E/ECE/324
E/ECE/TRANS/505/Rev.1/Add.47/Rev.1/Amend.3

Addendum 47: Regulation No. 48

Revision 1 - Amendment 3

UNIFORM PROVISIONS CONCERNING THE APPROVAL OF VEHICLES WITH REGARD TO THE INSTALLATION OF LIGHTING AND LIGHT-SIGNALLING DEVICES

6.5.5.2. or, at the discretion of the manufacturer, for M_1 category vehicles (**):

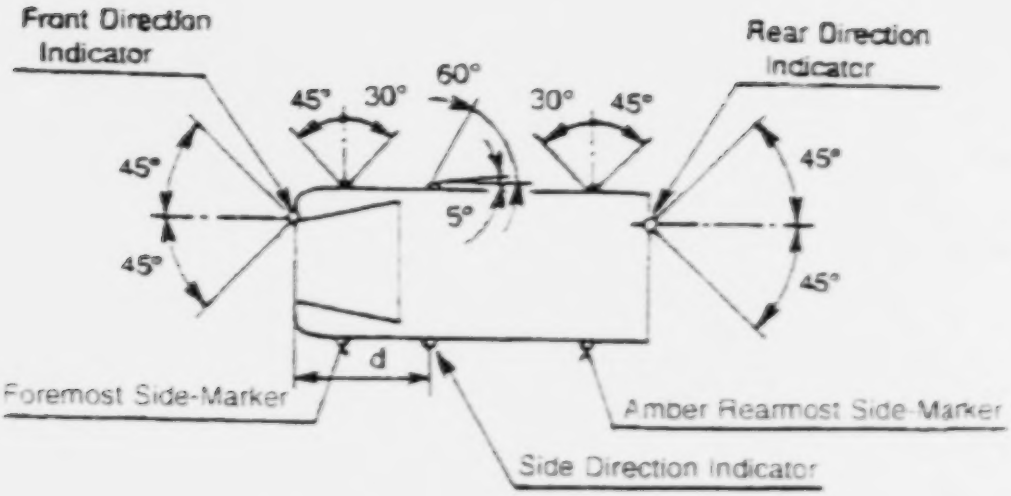
Paragraph 6.5.5., related to Direction Indicator Lamp, amend to read:

Front and rear direction-indicator lamps, as well as side-marker lamps
Horizontal angles see figure below:

(**) The value of 5° given for the dead angle of visibility to the rear of the side direction-indicator is an upper limit

$$d \leq 2.50 \text{ m}$$

Vertical angles: 15° above and below the horizontal. The vertical angle below the horizontal may be reduced to 5° if the lamps are less than 750 mm above the ground.

To be considered visible, the lamp must provide an unobstructed view of the apparent surface of at least 12.5 square centimetres, except for side direction-indicators of categories 5 and 6. The illuminating surface area of any retro-reflector that does not transmit light shall be excluded."
